STAFF REPORT

PZ 25-006 - PETITION: Rezoning. For a 14.75-acre tract, to rezone from R-30 (county) to MXU (city). The property is located at 0 and 7100 CH James Pkwy, within land lot 671, 2nd section, Cobb County Georgia. PIN: 19067100050, 19067100020. Applicant: Thompson Thrift Residential.

Consultant Review of site plan and architectural details.

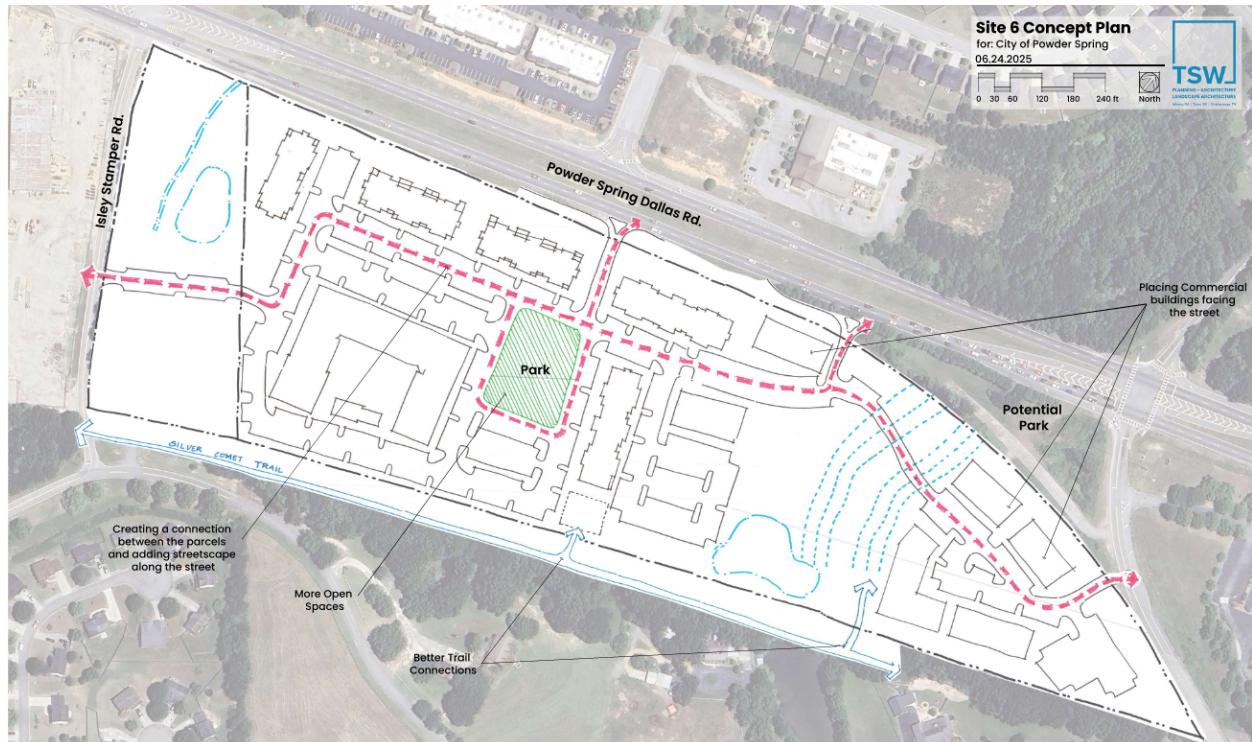
1. Lack of connectivity between parcels and needs a trail connection to the commercial. (page 16)
2. Lack of open space (page 18)
 - Multi-family (Paulding County parcels mostly have the greenspace, provide more details of the silver comet connection))
 - Commercial parcels
3. Commercial building placement (page 21)

4. Create a streetscape from Isley Stamper thru the property to the retail. (page 24-28)
5. Require Brick on 1st story with no other materials and use only two materials and patterns on the 2ⁿ and 3rd story. (page 40)
6. 6' stoop min. at doors (page 46)

- 15) Site plan be modified to be substantially consistent with that prepared by TSW dated June 24, 2025.
- 16) The detention pond shall be screened with landscaping subject to staff review. Underground detention shall be considered. Stormwater management facilities shall be designed by a registered landscape architect as formal or natural amenities for residents. The pond shall be designed to not require a fence or be enclosed by walls over 30 inches in height.
